IOWA DEPARTMENT OF TRANSPORTATION

TO OFFICE: Design	DATE: March 30, 2011
ATTENTION: Jim R. Schoenrock	REF. : Warren County
FROM: Robert L. Stanley	Proj. #: STPN-065-3(61)--2J-91
OFFICE: Design	PIN: 09-91-065-010
SUBJECT: Completed S1 Review

STPN-065-3(61)- -2J-91 S1 Review

Potential S1 Borrow

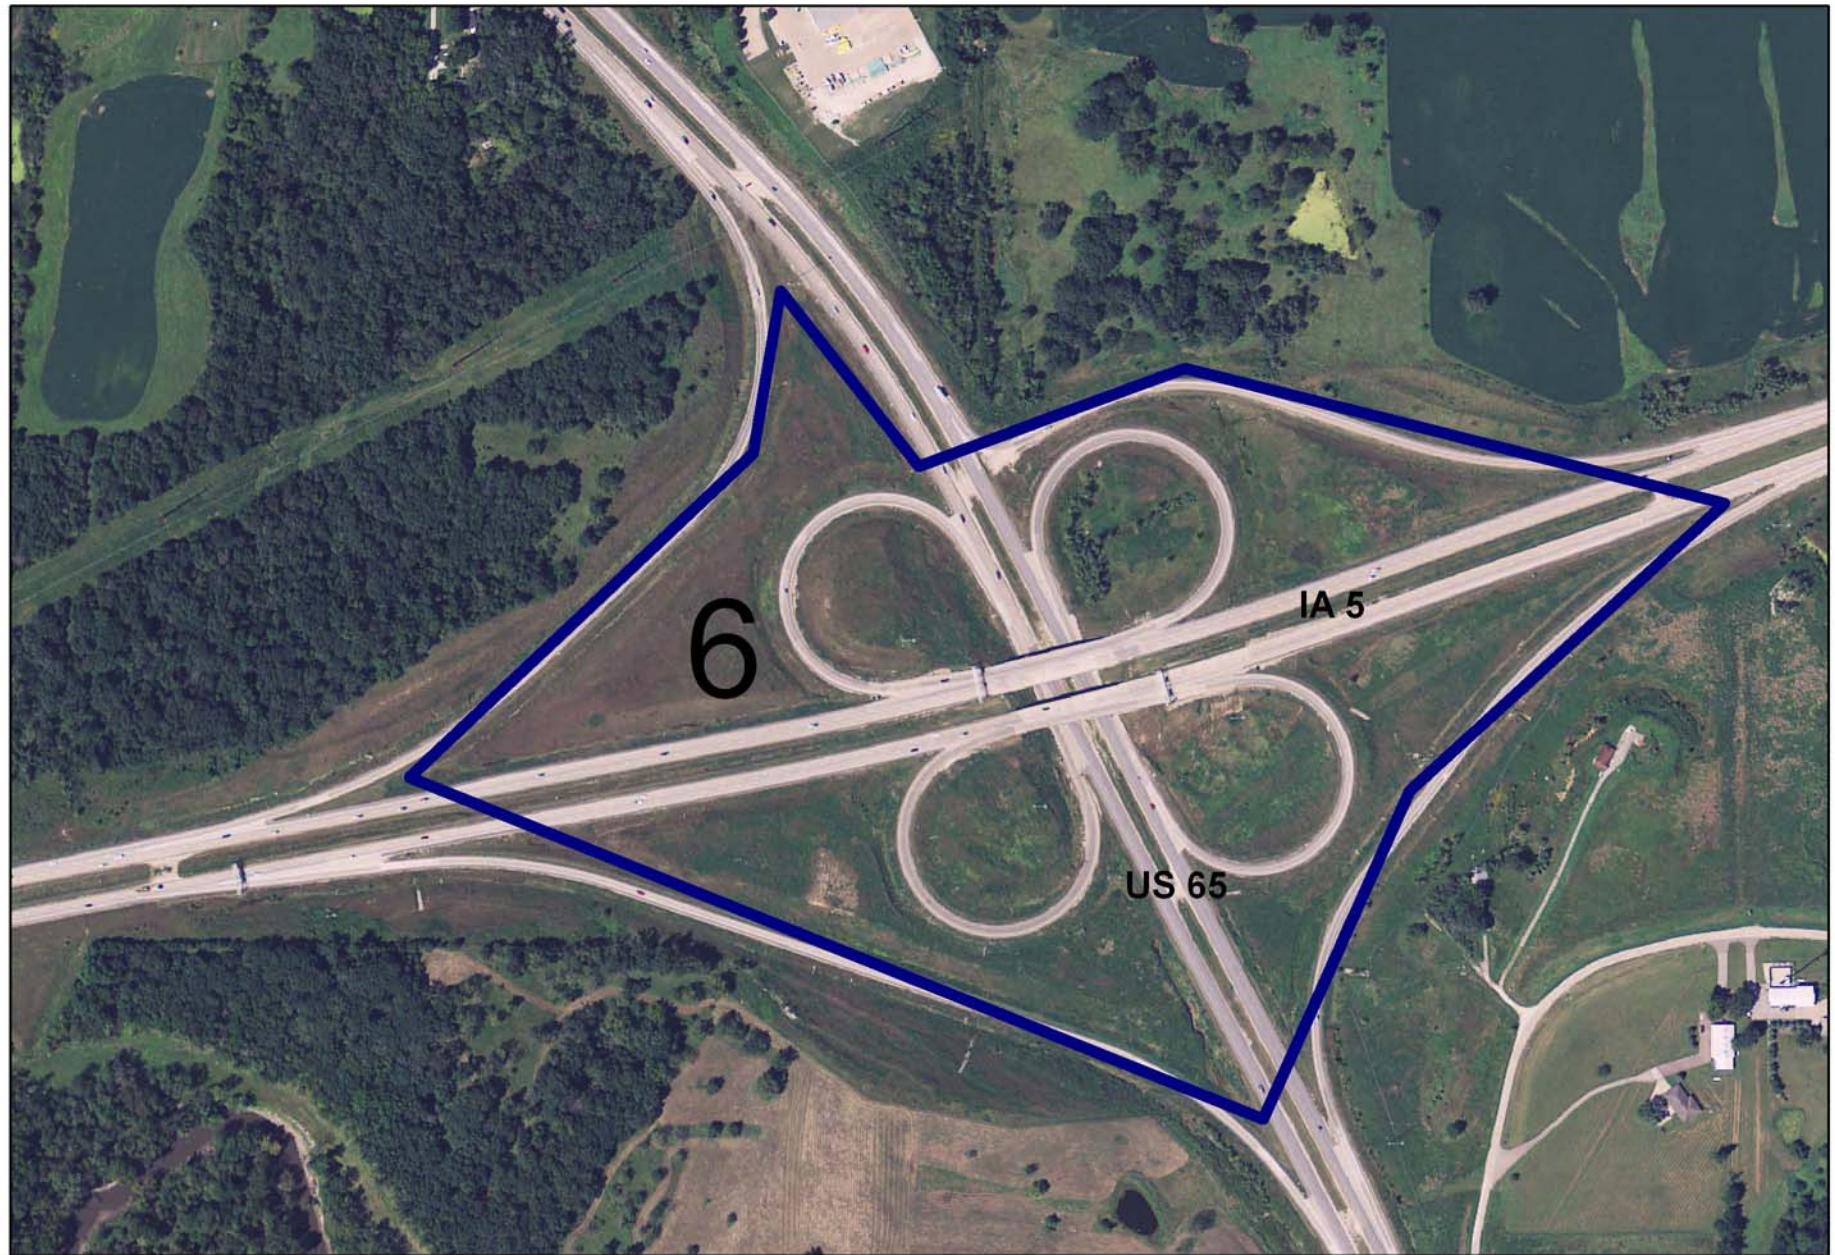
Potential Borrow Site 6: This site is approximately 75 acres and would make use of the excess material in the existing infield areas of the U.S. 65/IA 5 Interchange. The soils are derived from Glacial Till, Loess, Alluvium, and Paleosols. This site would be a drainable borrow.

Potential S1 Borrow

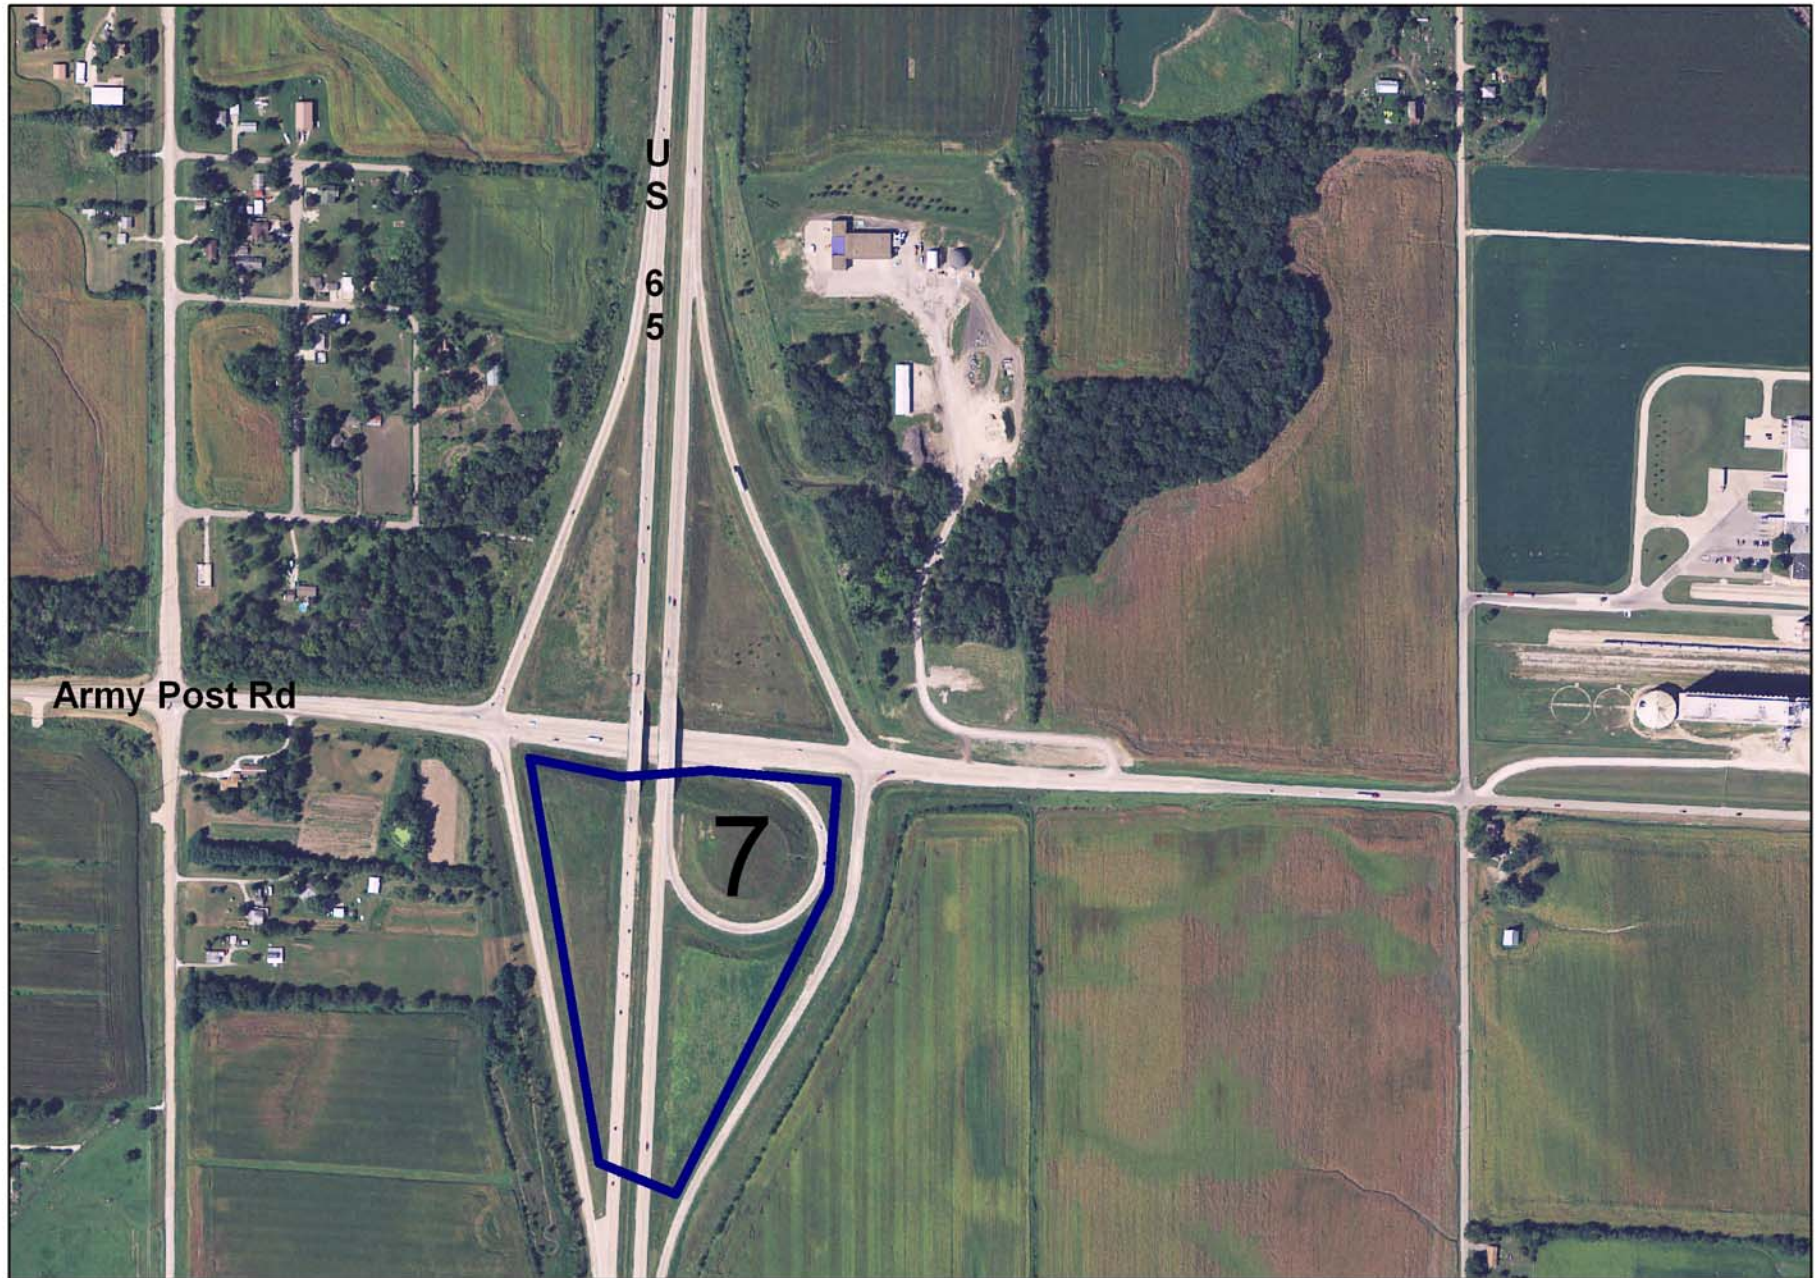
Potential Borrow Site 7: This site is approximately 18 acres and would make use of the excess material in the existing south infield areas of the U.S. 65/Army Post Rd. Interchange. The soils are derived from Alluvium, Loess, Glacial Till, and Colluvium. This site would be a drainable borrow.
